November 26, 2007

Re: AESO Reply Comments on EUB Approach to POD Cost Function

Figure 1: Chart of Error Range for DUC Recommended Power Curve Equation

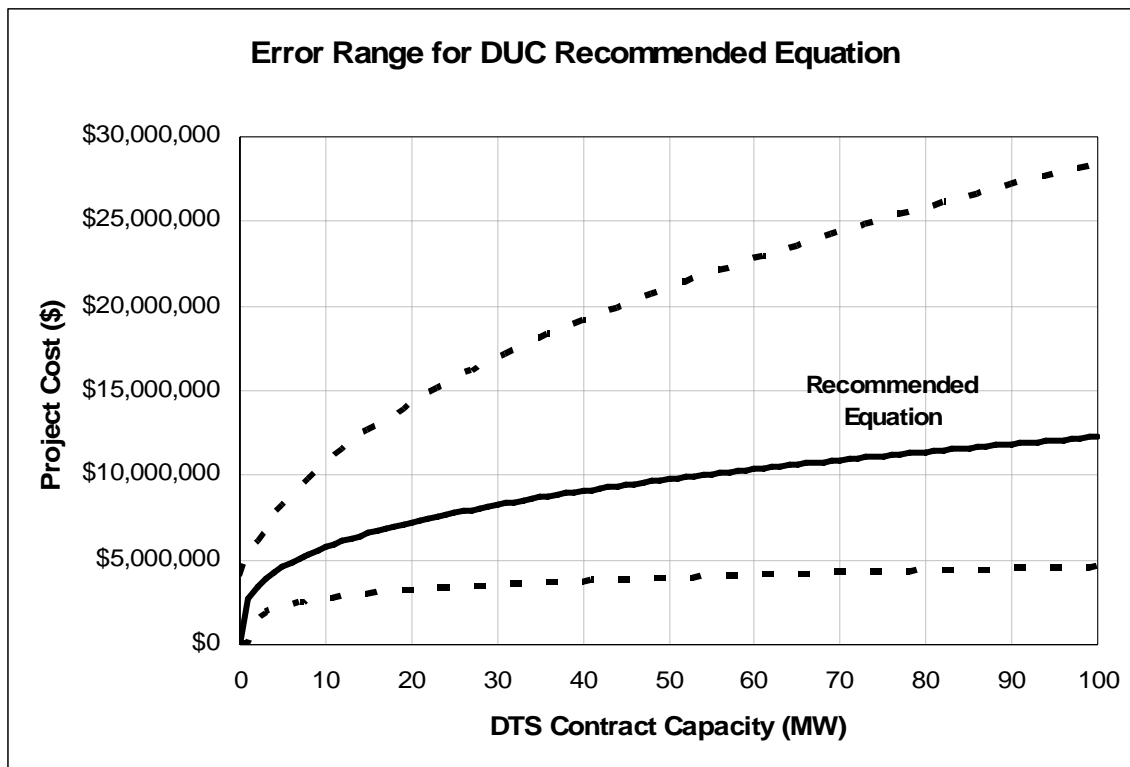
The combined effect of these error ranges is illustrated in Figure 1 below.

The other curves analyzed by DUC, as well as those suggested by the AESO in its comments and discussed in the AESO's information responses to the EUB, all have similar ranges of error, reflecting the limited data from which the curves were developed. Given the large range of error, the AESO submits that selecting a curve based simply on highest coefficient of determination (r^2) ignores the significant uncertainty surrounding the equation. In the face of such uncertainty, the AESO suggests consideration be given to the additional rate design principles developed by Bonbright and summarized in section 4.2 of the AESO's Application (Exhibit 005, page 4): stability and predictability, and practicality such that rates are appropriately simple, convenient, understandable, acceptable, and billable. It is important to keep in mind that the purpose of the rate design exercise is to derive a fair and equitable charge for service from the transmission system.

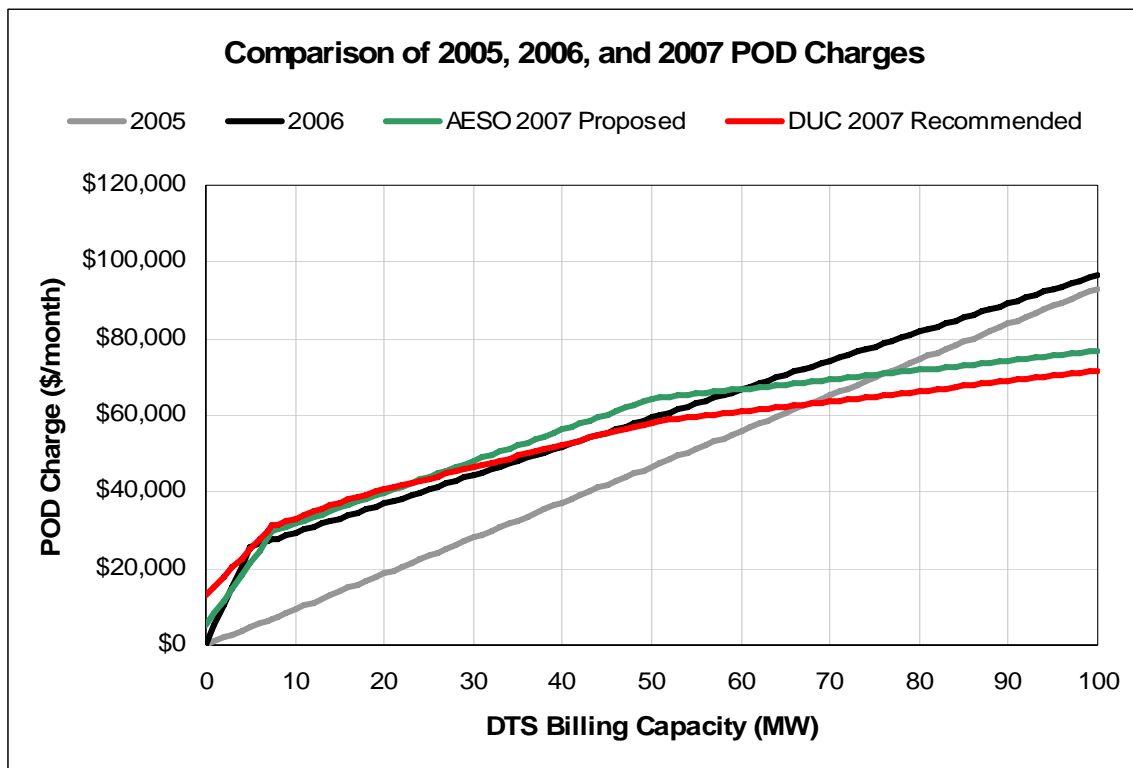
The AESO also provides in Figure 2 a comparison of the POD charges from the 2005 and 2006 AESO approved tariffs, based on the AESO's recommended cost function, and based on DUC's recommended cost function.

The AESO suggests that Figure 2 illustrates the shifting of costs from larger services to smaller services since 2005, a matter discussed in detail in section 4.5.3 of the AESO's Application (Exhibit 005, pages 22-33) and during this proceeding. The AESO also suggests the further shifting of costs to smaller services that would arise from adopting the DUC recommended cost function is not warranted based on the limited data examined in this proceeding.
